ADDENDUM No. 1

PROJECT NAME: INGRAM ROAD (CULEBRA ROAD TO MABE ROAD) – ID NO.:40-00307

DATE: October 13, 2014

INGRAM RD. RECONSTRUCTION
STORM SEWER SYSTEM "A"
TRUNKLINE (RT) &
LATERAL PROFILE

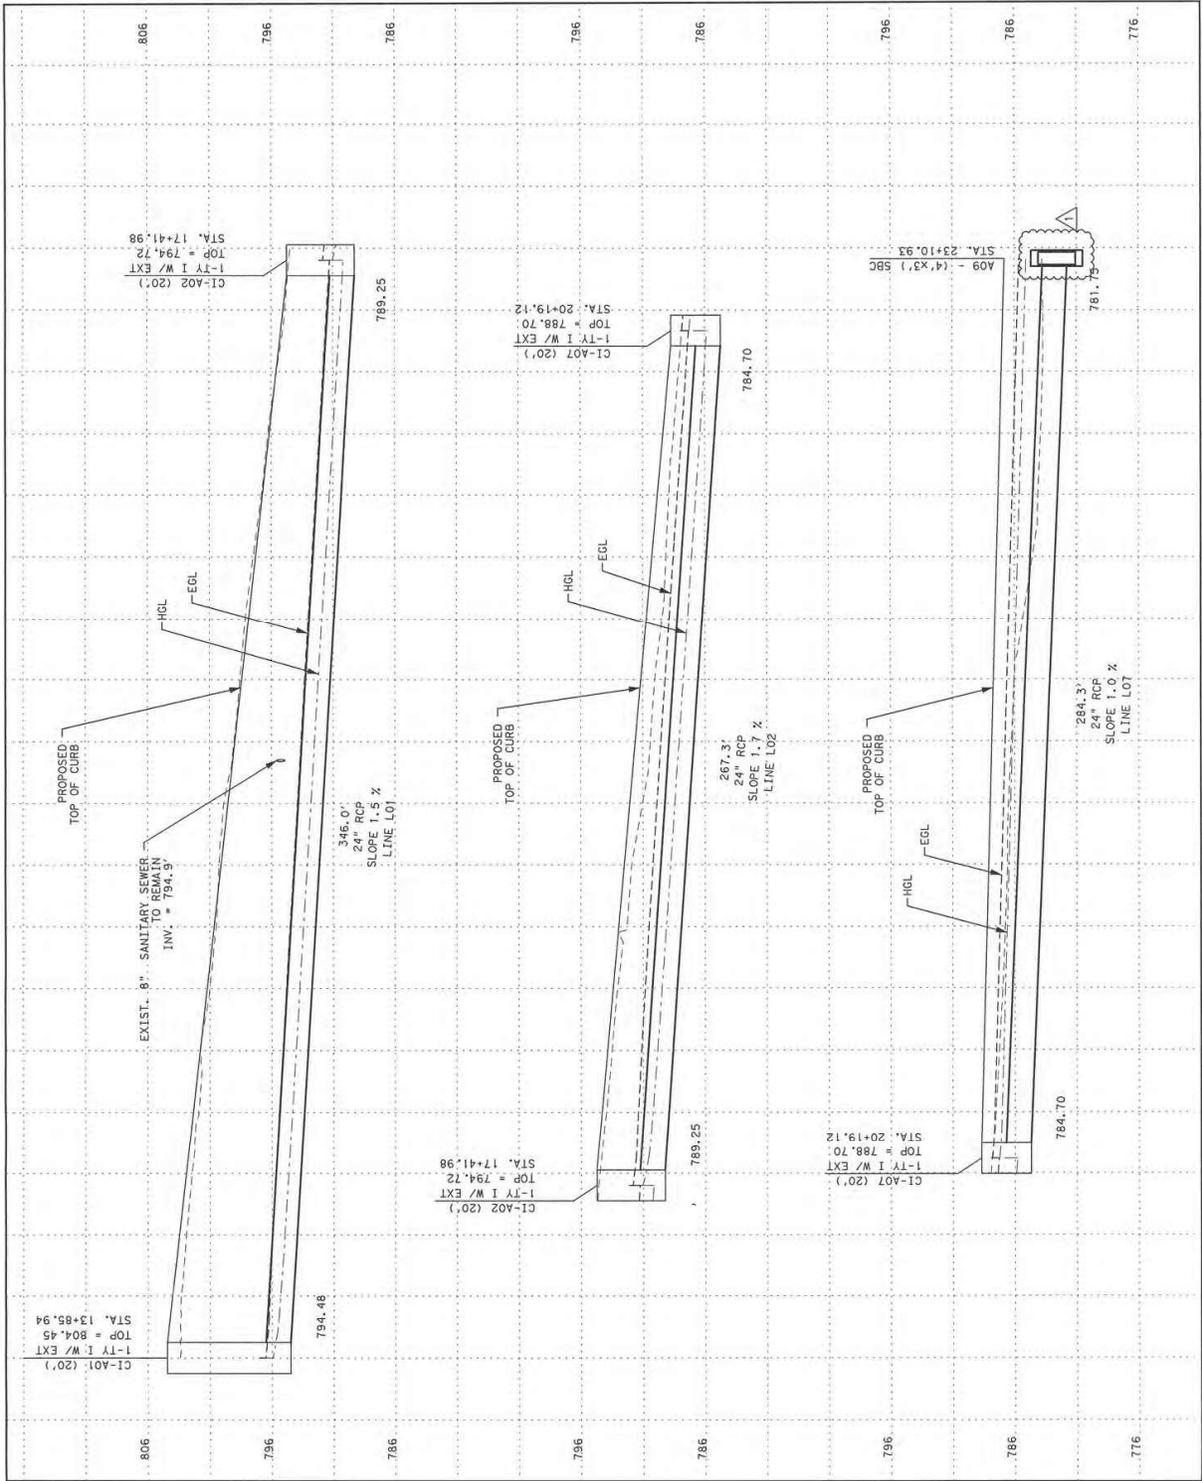
NO.	REVISION	DATE	DESIGNER	APPROVER
1	ADDENDUM 1 - UPDATE STORM SEWER PROFILE	10/09/14

INGRAM RD. RECONSTRUCTION
STORM SEWER SYSTEM "A"
TRUNKLINE (RT) &
LATERAL PROFILE

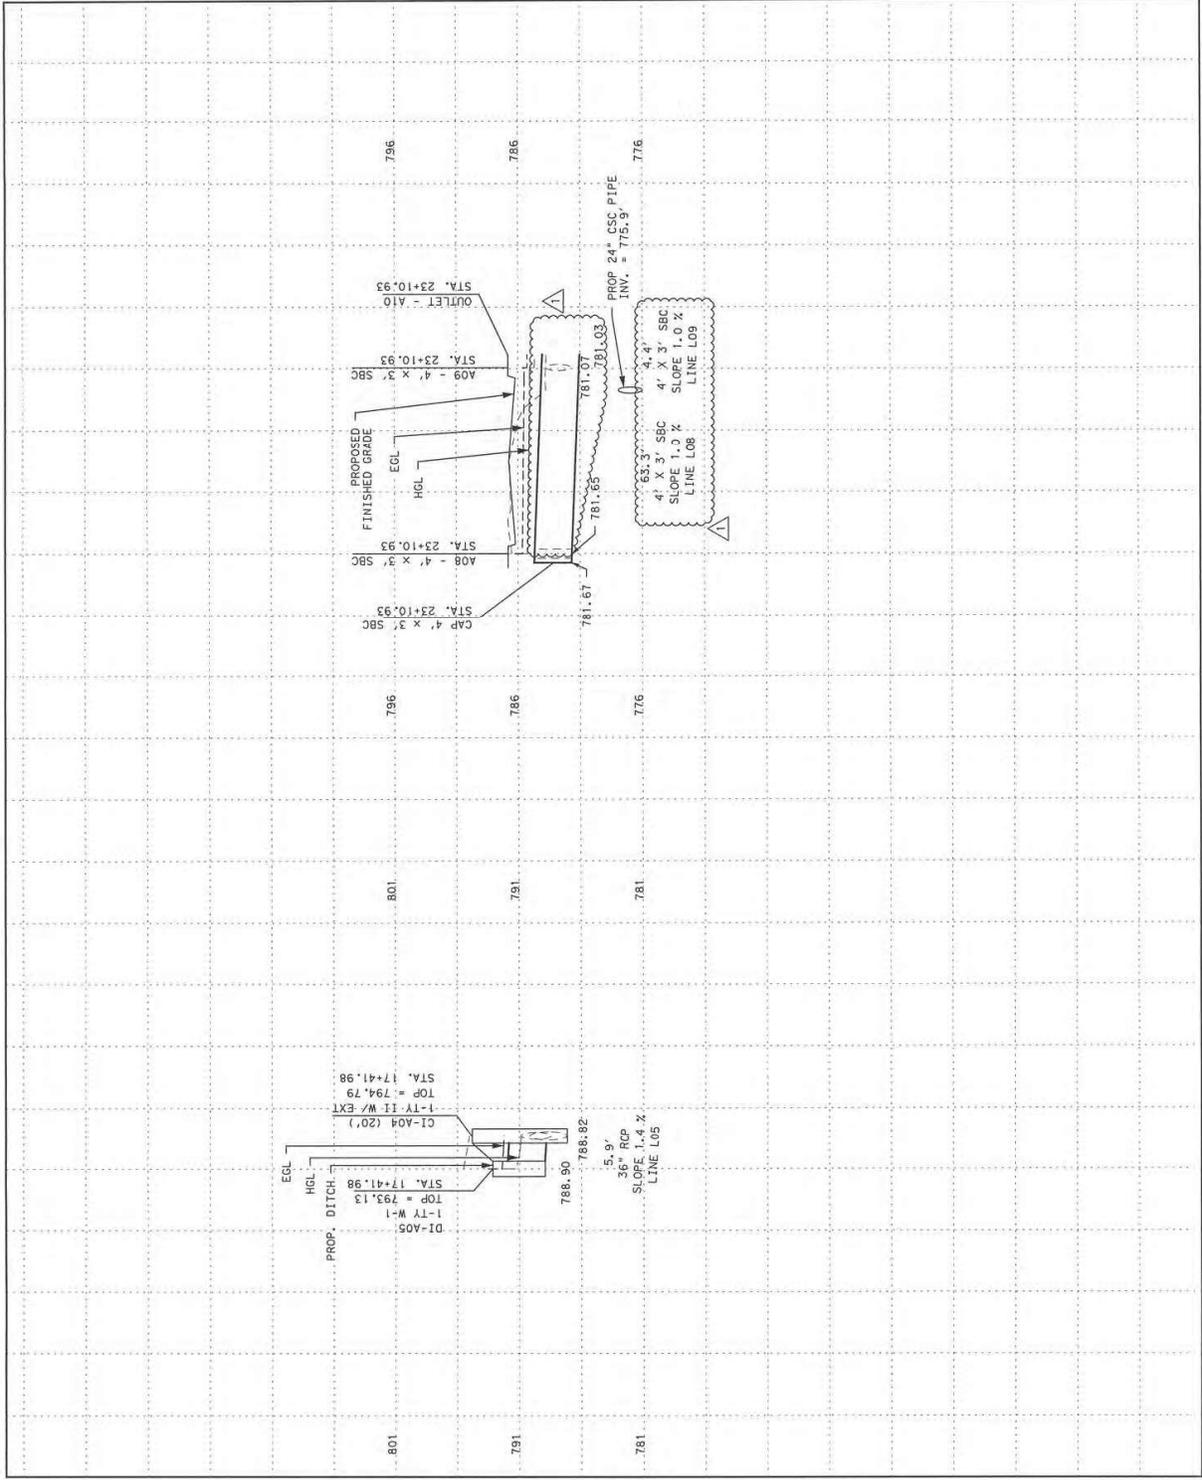
- 6) On sheet 246, the 4'x3' SBC does not show how the line will tie into the outfall. If it is to tie into the headwall, will it change the design of the headwall, the rip rap tying into the headwall, and the channel excavation beneath the riprap?

- a) The 4'x3' SBC will tie into the headwall. Please see attached plan revisions. These changes do not affect the quantities.

DRAINAGE OUTLET C-17
NOT TO SCALE

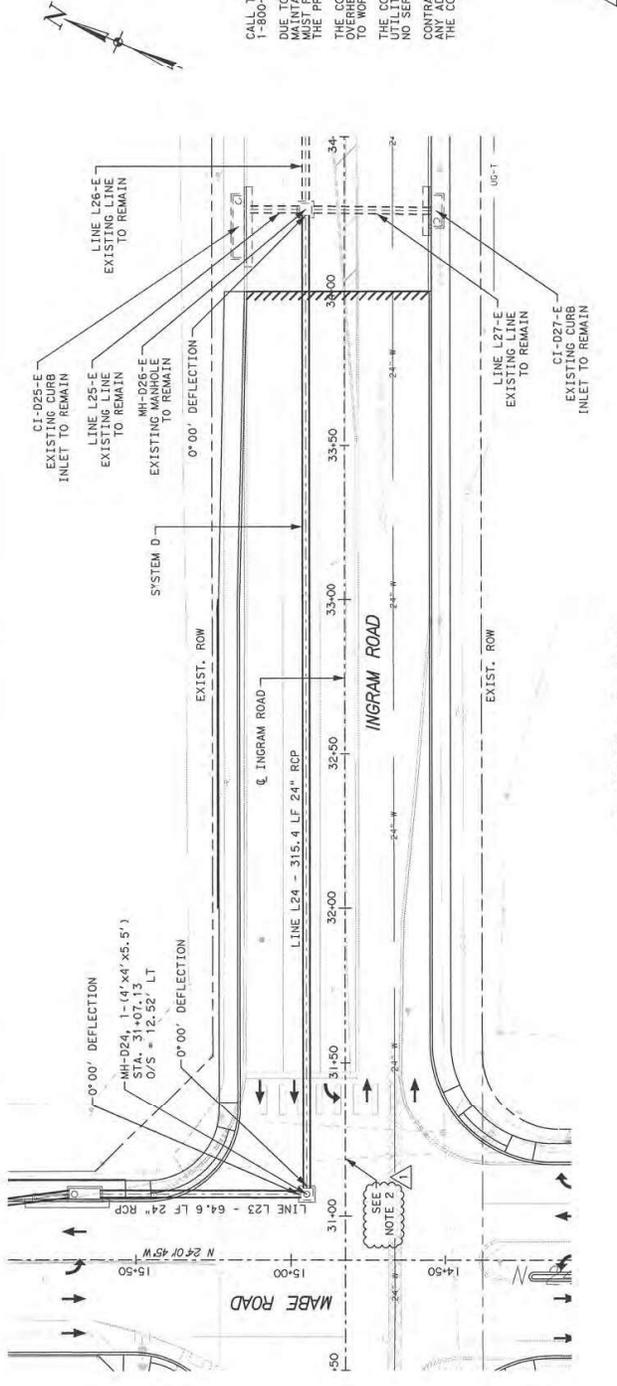
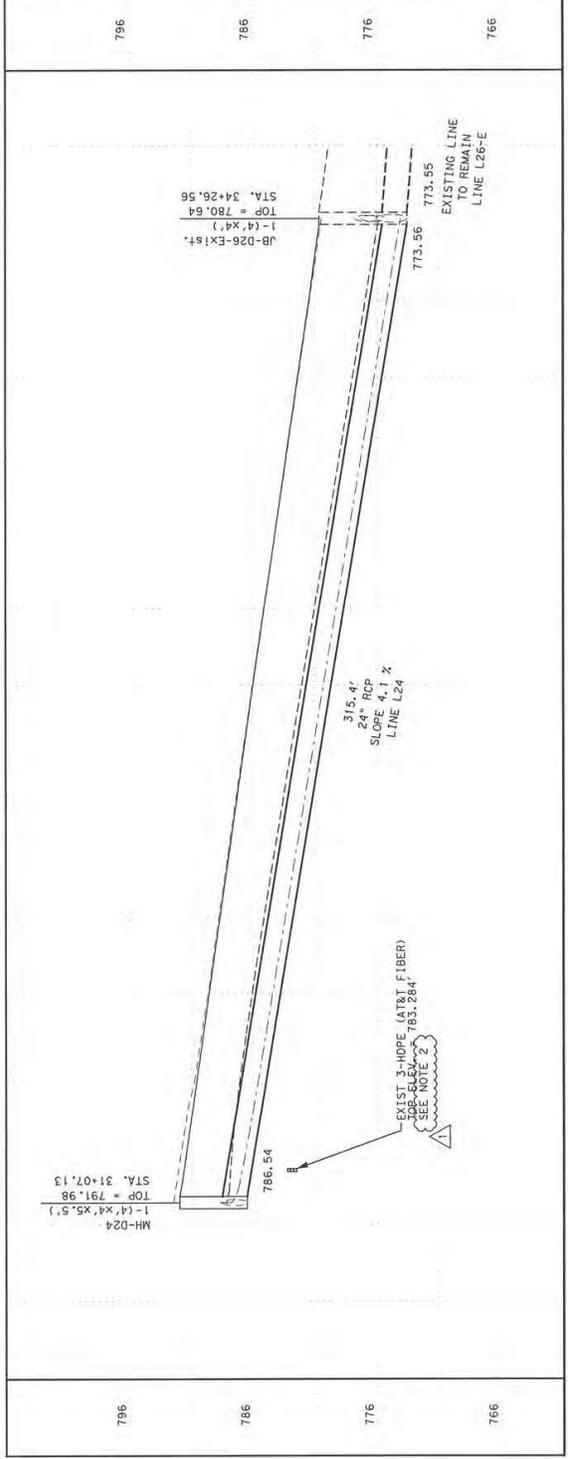
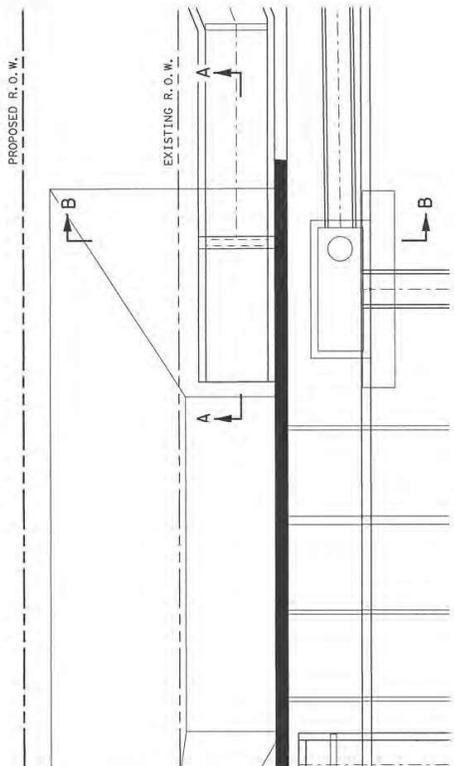
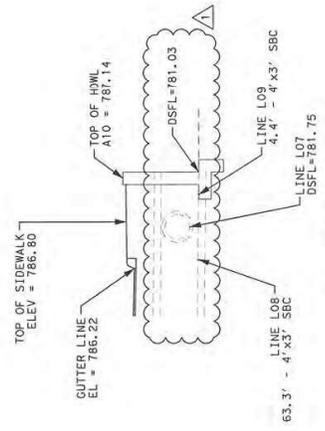
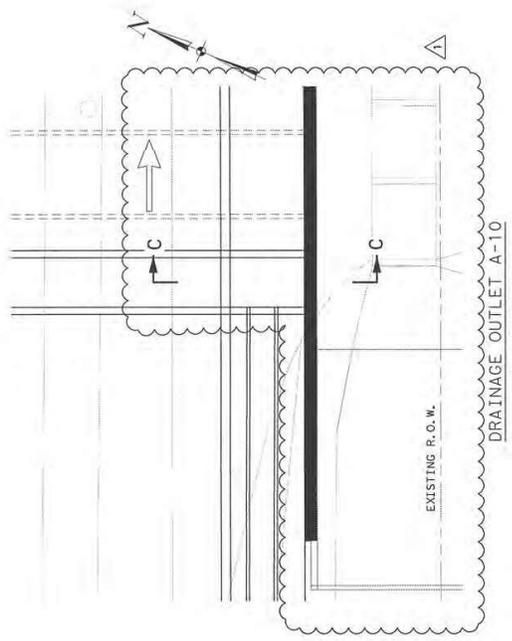
NO.	REVISION	DATE	DESIGNED	CHECKED	DATE
1	ADDITIONAL - UPDATED DETAIL	10-09-14
